Technical Newsletter

November 2024 Service Operation Team

Information on the additional Safety Wire installation option for 5-Channel Multi-Cameras

Instructions on how to repair thermal imaging cameras by their fault locations

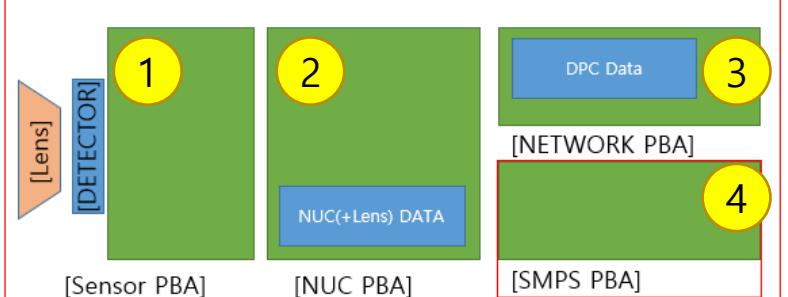
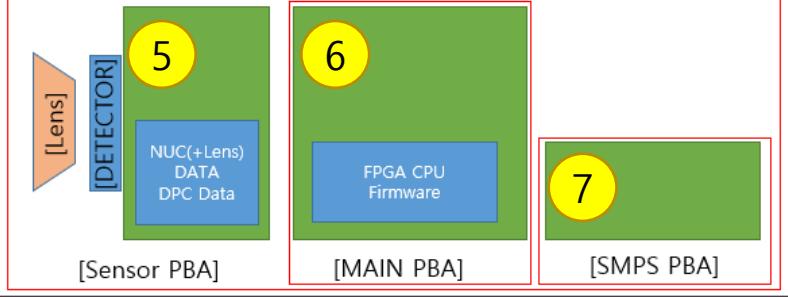
- To provide a guideline on replacement by combining parts with sensor-specific information when repairing thermal imaging camera parts.

No	Parts Name	Single Replacement	Remark
①	Sensor PBA	Impossible	Replace the upper Ass'y set (①+②+③+ [Lens]) + sensor-specific information
②	NUC PBA		
③	NETWORK PBA		
④	SMPS PBA	Possible	
⑤	Sensor PBA	Impossible	Replace the upper Ass'y set (⑤ + [Lens]) + sensor-specific information
⑥	Main PBA	Possible	
⑦	SMPS PBA	Possible

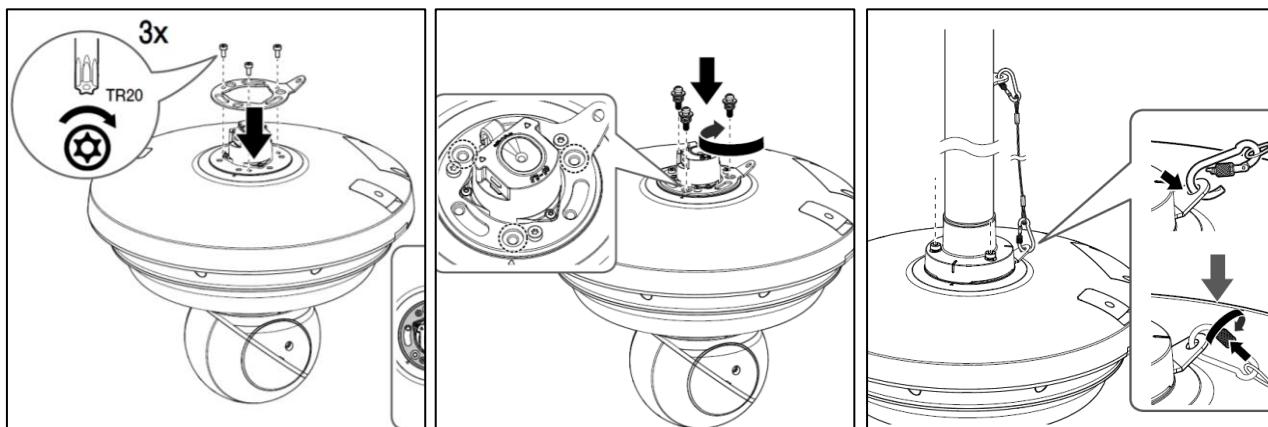
- Adding the option to secure the camera to an external pole for camera drop prevention

- Products before Nov. 2024: The safety wire can be used after replacing the 4 accessories shown below.
- Products after Nov. 2024: The 4 accessories below are provided as standard.
